Customer	: CU-DAR001 Dart Helicopters Services	Drawing Name	: HELI ACCESS STEP EXT HIGH GEAR RH
Job Number	: 34976		
Estimate Number	: 12875		
P.O. Number	: N/A	Part Number	: D205633026
This Issue	: 10/3/2007 S.O. No. : N/A	Drawing Number	: DSI 9300 REV B
Prsht Rev.	: NC	Project Number	: N/A
First Issue	: N/A Type : LARGE FAB ASSY	Drawing Revision	: B
Previous Run	: 32509	Material	: N/A
Written By	: <u>KS 07.10.03</u>	Due Date	: 10/30/2007 Qty: 2 Um: Each
Checked & Approved By	: <u>KS 07.10.03</u>		
Comment	: Est Rev:B Added D3165-1 KJ/JLM 05-09-09

DESIGN RF	DRAWN BY RF	DART AEROSPACE LTD HAWKESBURY, ONTARIO, CANADA	
CHECKED 	APPROVED 	DRAWING NO. DSI 9300	REV. B SHEET 1 OF 6
DATE 05.08.12		TITLE SIMPLEX TANK STEP	SCALE NTS
A	05.05.05	NEW ISSUE	
B	05.08.12	ADD STRUTS IF TANK REMOVED

DART SERVICE INSTRUCTION

TO AMEND INSTALLATION INSTRUCTIONS IIN-D205-633 REV. A

DETAIL S
NOT TO SCALE

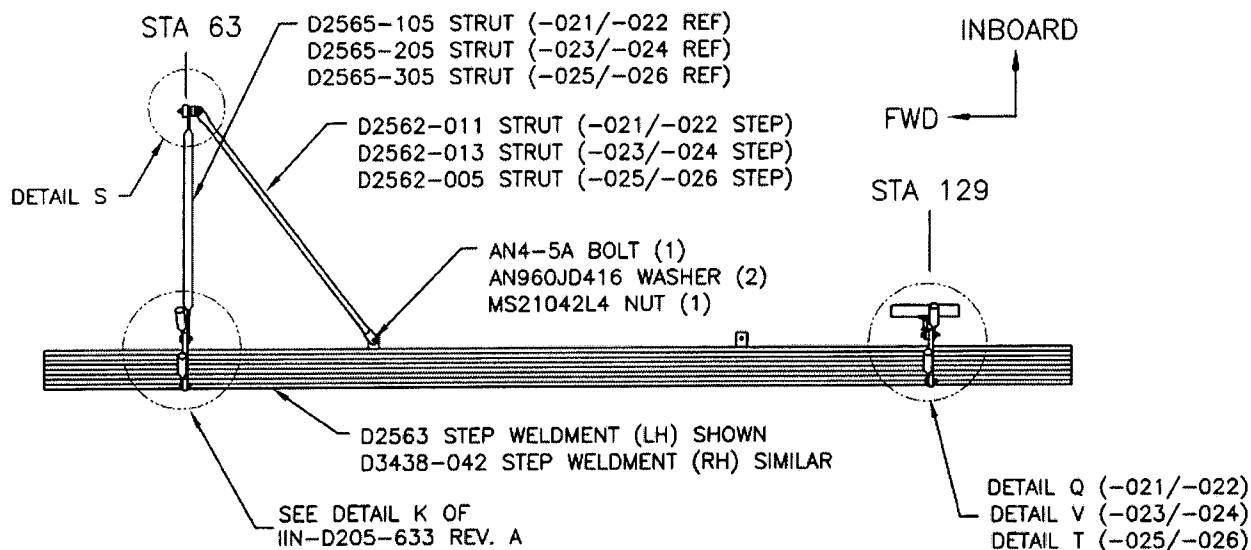
INSTALLATION OF D205-633-021/-022/-023/-024/-025/-026

INSTALL D205-633-021/-022 AS PER THE D205-633-011 STEP OF INSTALLATION INSTRUCTIONS IIN-D205-633 REV.A, EXCEPT REPLACE D2565-111 STRUT WITH THE D3437-041 AFT STRUT ASS'Y, REMOVE D2562-001 STRUT, INSTALL D2562-011 STRUT AS SHOWN.

INSTALL D205-633-023/-024 AS PER THE D205-633-013 STEP OF INSTALLATION INSTRUCTIONS IIN-D205-633 REV.A, EXCEPT REPLACE D2565-211 STRUT WITH THE D3437-043 AFT STRUT ASS'Y, REMOVE D2562-003 STRUT, INSTALL D2562-013 STRUT AS SHOWN.

INSTALL D205-633-025/-026 AS PER THE D205-633-015 STEP OF INSTALLATION INSTRUCTIONS IIN-D205-633 REV.A, EXCEPT REPLACE D3165-1 SUPPORT ARM WITH THE D3437-045 AFT STRUT ASS'Y AS SHOWN.

D205-633-021/-023/-025 SHOWN.
D205-633-022/-024/-026 SIMILAR
(VIEW LOOKING DOWN)
